**BBCO Wastewater Pretreatment
25 Omega Dr.
Williston, VT 05403
D&K Project No. 530759
ADDENDUM NO. 1**

This Addendum forms part of the Contract Documents and modifies the original Bidding Documents dated January 30, 2026. **NOTE: Contractor to Acknowledge receipt of this Addendum in the space provided on Page 1 of the Bid Form. Failure to do so may subject the Bidder to disqualification.**

PROJECT NAME:
BBCO
Wastewater
Pretreatment

SHEET NUMBER
E6.1

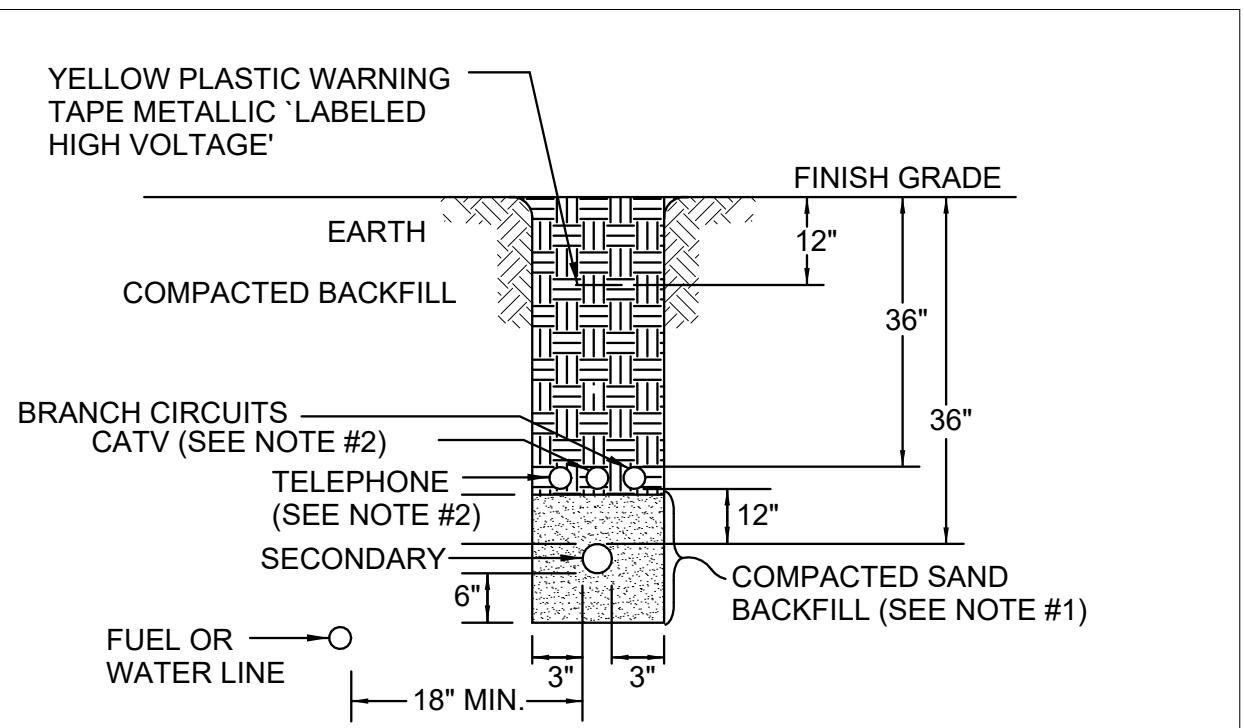
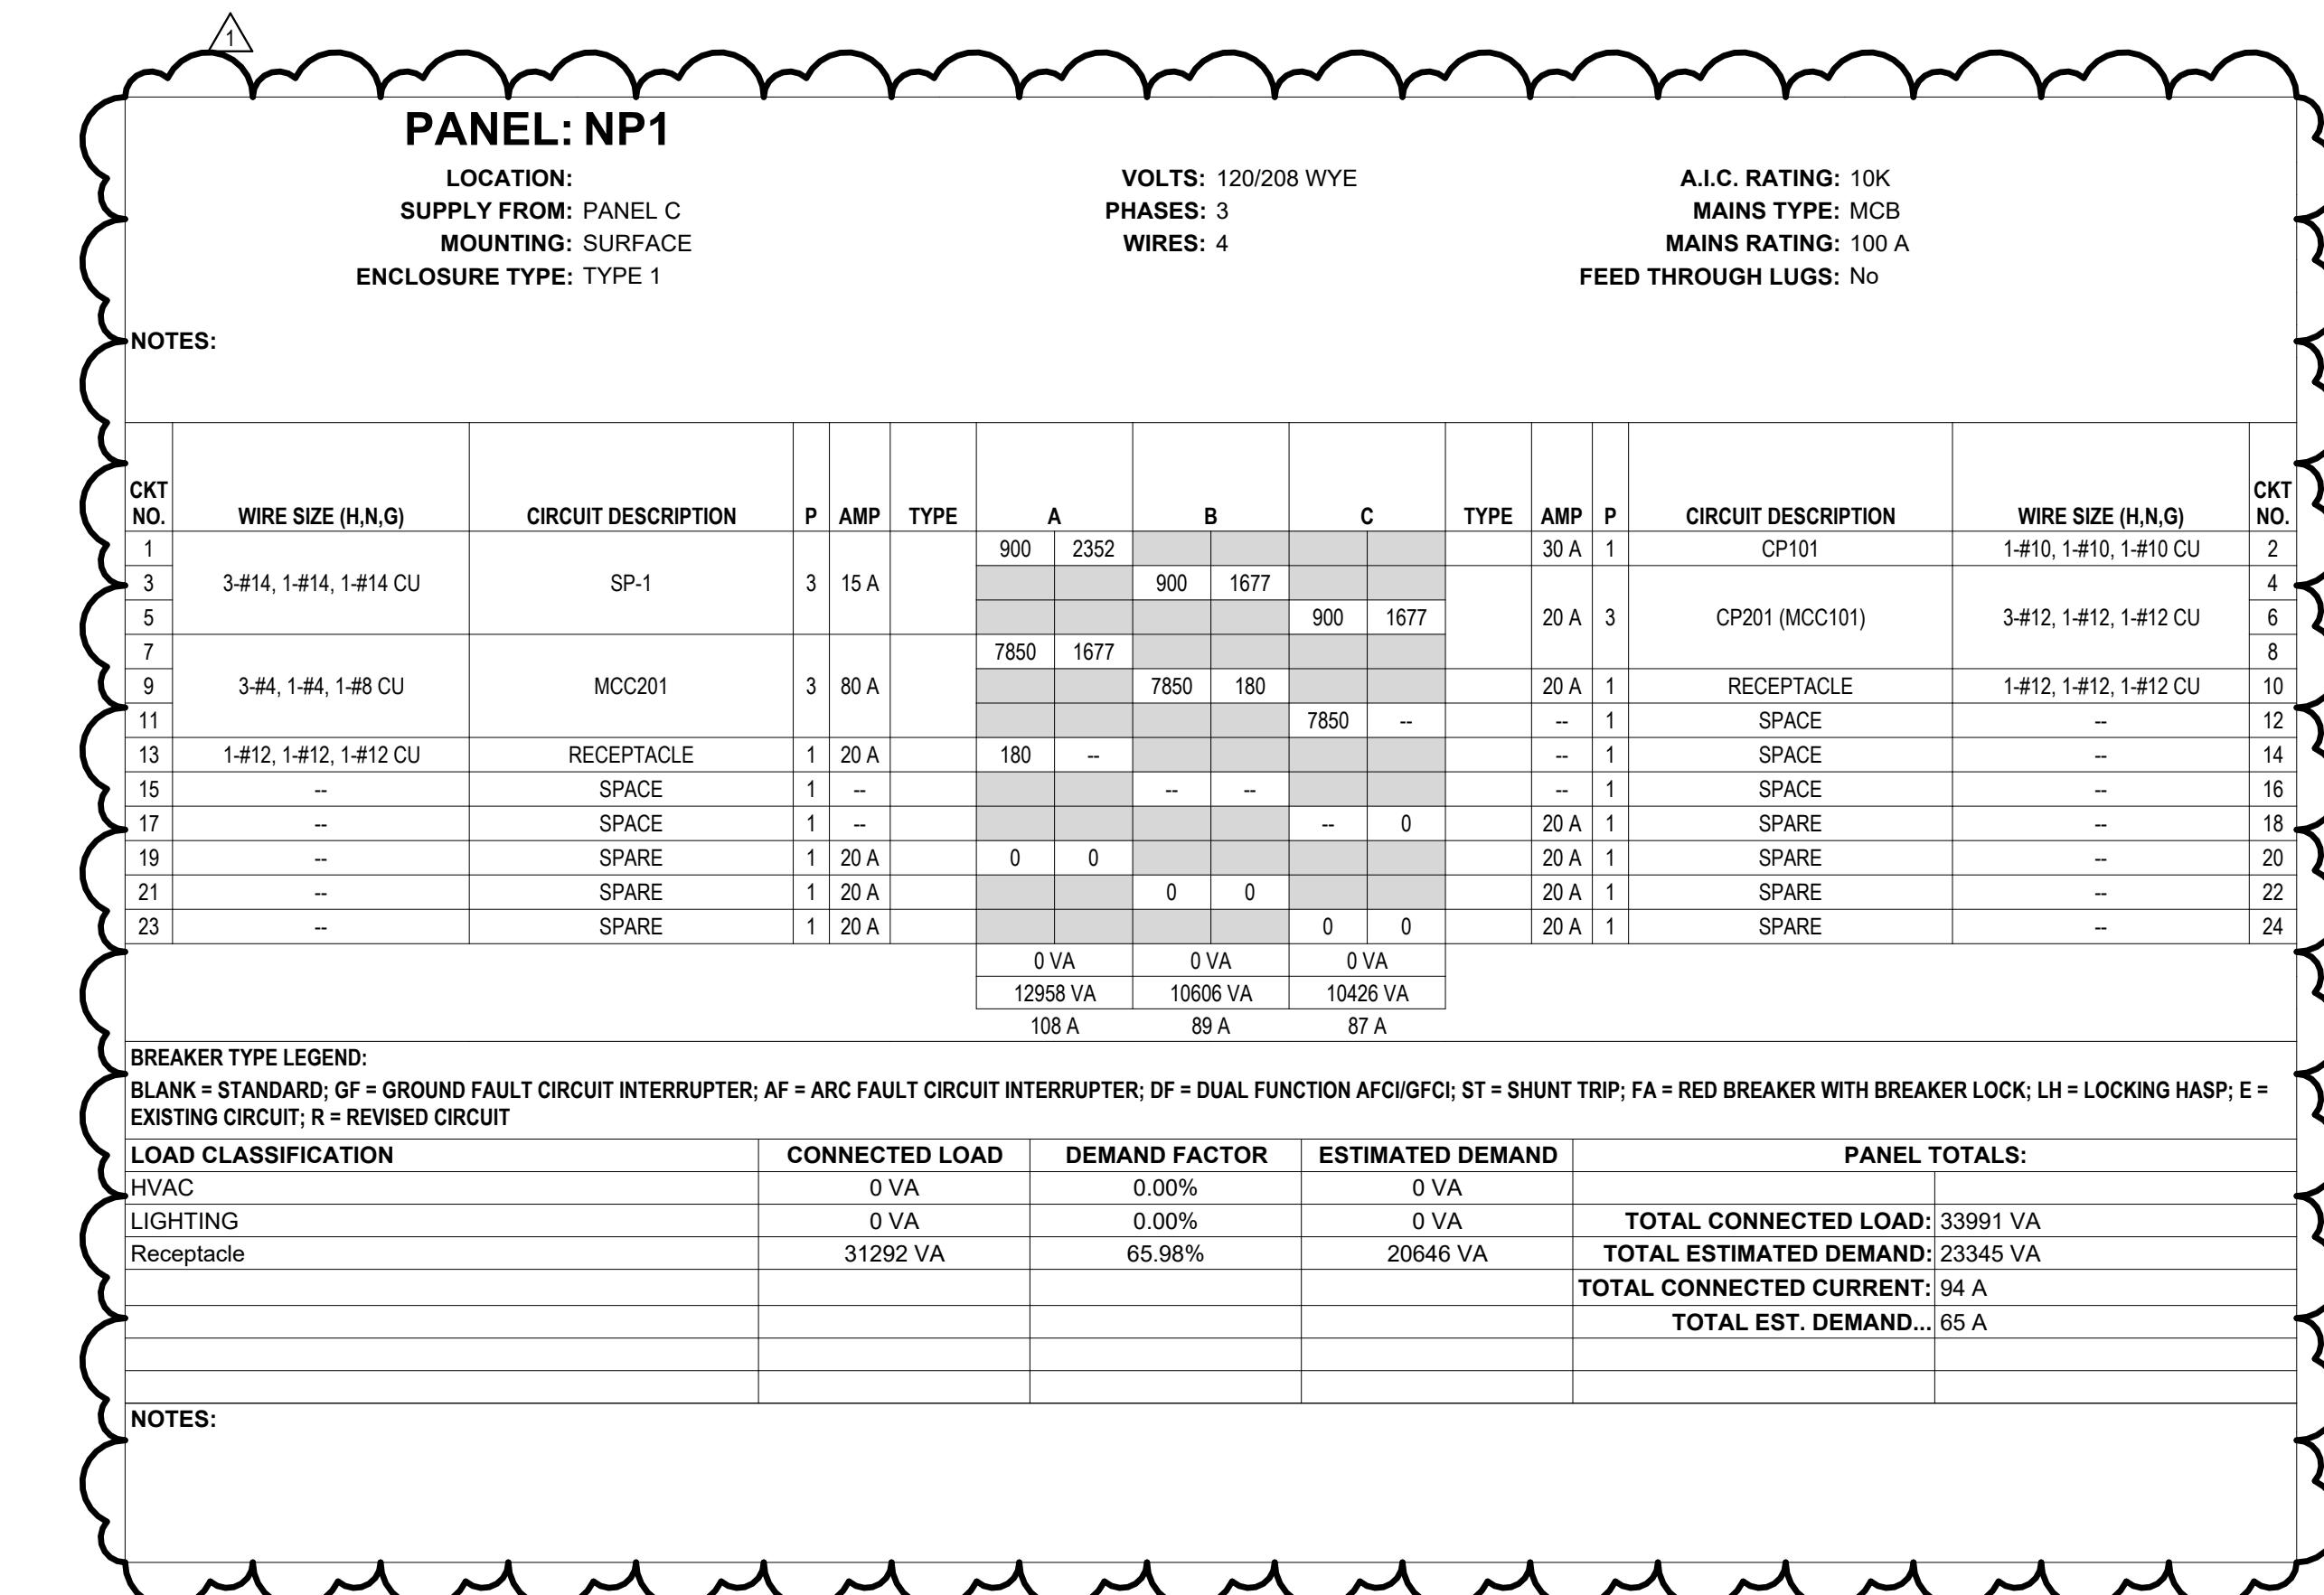
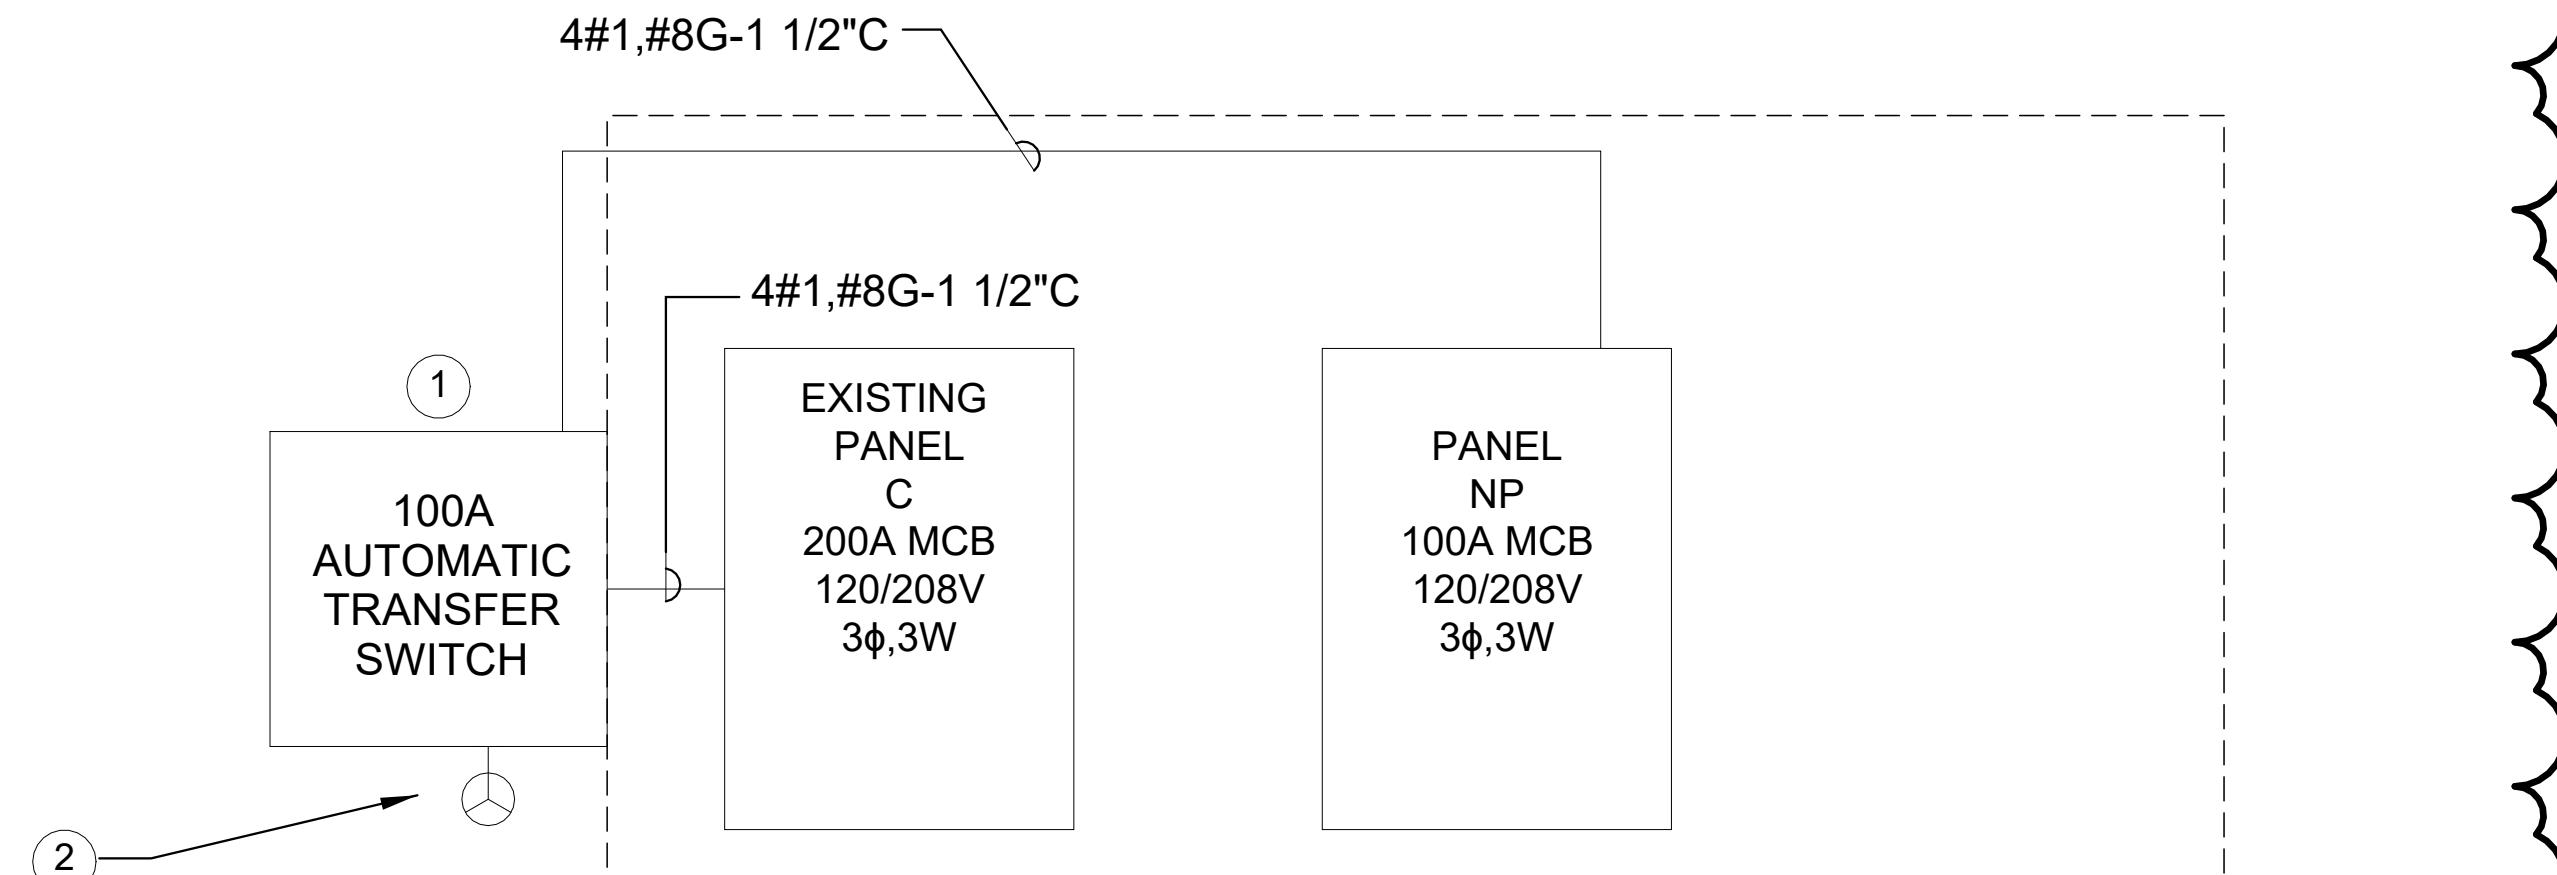
2. Sump pump schedule on drawing P0.1 indicates three phase, while schedule on drawing E1.1 and panel schedule on drawing E6.1 indicates single phase. Which is correct?

3. Drawing E1.1, Who is supplying the 150amp ATS? There's no notes or specs on this item.

4. Do we assume panel NP1 feeder is wired thru the ATS. Drawings do not indicate.

Response: SP-1 to be three phase. Refer to attached revised E1.1 and E6.1.

Response: Contractor to supply ATS. Refer to attached revised E6.1.

Response: Yes, refer to attached revised E6.1.
